UNITED STATES PATENT AND TRADEMARK OFFICE

10/549,682

Office Action Summary	Application No. 10/549,682	Applicant(s) SCHROECK ET AL.	
	Examiner BRYAN D. RIPA	Art Unit 1795

DETAILED ACTION

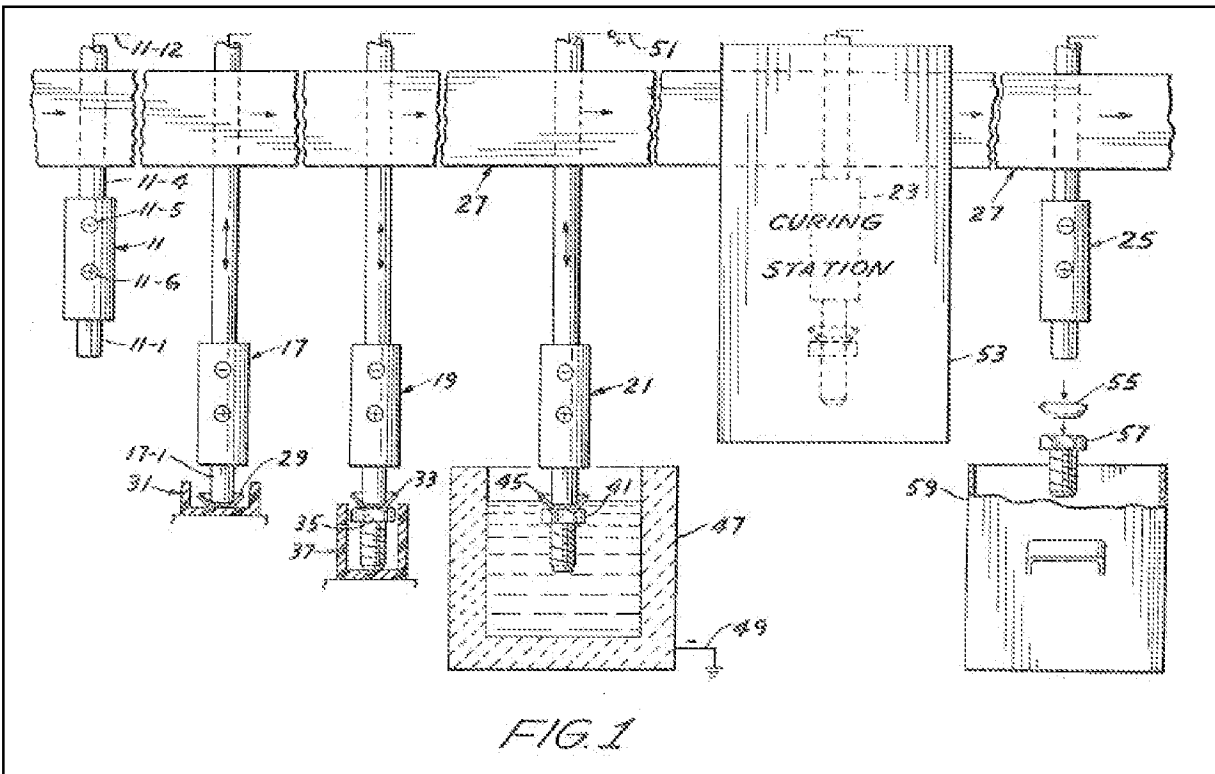
Regarding claim 1, JOHNSON teaches an apparatus for electrodeposition which is capable of functioning for the electrodeposition of shaped dental parts such as skeletons for crowns, inlays, bridges and the like (see generally col. 1 lines 20-22 teaching the apparatus for the electrodeposition of small objects) having at least one current/voltage source and electrodes which can be arranged in a vessel that can be filled with an electrolyte (see col. 3 lines 34-36 teaching the workpiece being electrically connected to a power source that acts as an electrode; see also col. 3 lines 29-34 teaching tank 47 being filled with a coating bath, i.e. an electrolyte), wherein there is at least one magnetic connecting means for producing the electrical contact for the

electrodeposition between at least one electrode and the current/voltage source (see col. 1 lines 49-58 teaching the assembly 21 comprising an electromagnet acting as a magnetic connecting means through which electrical contact is made to the workpiece).
See figure 1 below.

Regarding claim 2, JOHNSON teaches the apparatus for electrodeposition wherein the magnetic connecting means comprises two parts which interact with one another through magnetic force (see assembly 21 and workpiece 41 comprising two parts which interact with one another through magnetic force). See figure 1 above.

Regarding claim 4, JOHNSON teaches the apparatus for electrodeposition wherein the magnetic connecting means comprises a magnet and magnetizable metal part (see assembly 21 and bolt 41 above comprising an electromagnet, i.e. a magnet, and a magnetizable metal part). See figure 1 above.

Regarding claim 5, JOHNSON teaches the apparatus for electrodeposition wherein the magnet has a round cross-sectional area (see core 17-1 comprising the contact of the electromagnet and having a round cross-sectional area). See figure 1 above.

Regarding claim 6, JOHNSON teaches the apparatus for electrodeposition wherein one of the parts of the magnetic connecting means, in particular a magnet, is assigned to the current/voltage source (see assembly 21 electrically connected to conduct 51 which is connected to the power source; see also col. 3 lines 34-36). See figure 1 above.

Regarding claim 7, JOHNSON teaches the apparatus for electrodeposition wherein the part, in particular the magnet, is assigned to a head or cover part which during electrodeposition is located above the vessel that can be filled with the electrolyte and at which the electrodes are preferably also arranged (see assembly 21 comprising a head or cover part which is located above tank 47). See figure 1 above.

Regarding claim 8, JOHNSON teaches the apparatus for electrodeposition wherein the magnet is arranged in a sleeve-like component (see thimble 45 acting as a

sleeve like component that is arranged around the electromagnet connecting core).

Regarding claim 9, JOHNSON teaches the apparatus for electrodeposition wherein one part of the magnetic connecting means is assigned to an electrode or part of an electrode (see assembly 21 and col. 3 lines 34-36 teaching bolt 41, i.e. the workpiece, connected to the power supply through assembly 21 so as to act as an electrode during the electrodeposition). See figure 1 above.

Regarding claim 10, JOHNSON teaches the apparatus for electrodeposition wherein the electrode or the electrode part is of a rod-like design (see assembly 21). See figure 1 above.

Regarding claim 11, JOHNSON teaches the apparatus for electrodeposition wherein the magnet is arranged in a sleeve-like receptacle in the electrode or in the electrode part (see thimble 45 acting as a sleeve like component that is arranged around the electromagnet connecting core in assembly 21). See figure 1 above.
